# Access Compliance Report Public Rights-of-Way (Curb Ramps)

| Main Street: VALENCIA_AVE |                                  | Cross Street: BIRCH_ST  |                        | Location:       | NW |
| ADA ID: RPAT210920144940  | Ramp Type:Type 1 - Perpendicular | Initial Pass/Fail: Pass | Overall Compliance: No | Severity Score: | 5  |

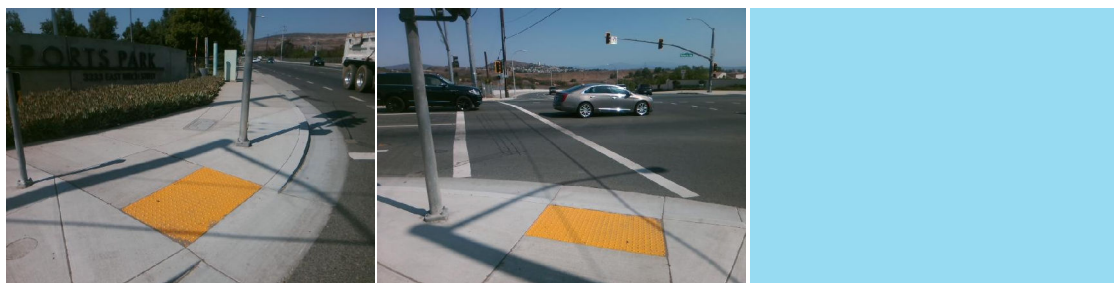
| Compliance | Description                           | Data | Compliance | Description                   | Data   |
|------------|---------------------------------------|------|------------|-------------------------------|--------|
| No         | Landing Cross Slope (%)               | 5.5  | Yes        | DWS Provided                  | Yes    |
| Yes        | Gutter Ponding                        | No   | No         | Curb Slope                    | 9.4    |

|             | Remove & Replace Entire Ramp. Utility Present. |                              |      |  |  |
|             |                                                | R304.2.2, R304.5.3, STD 1115 |      |  |  |
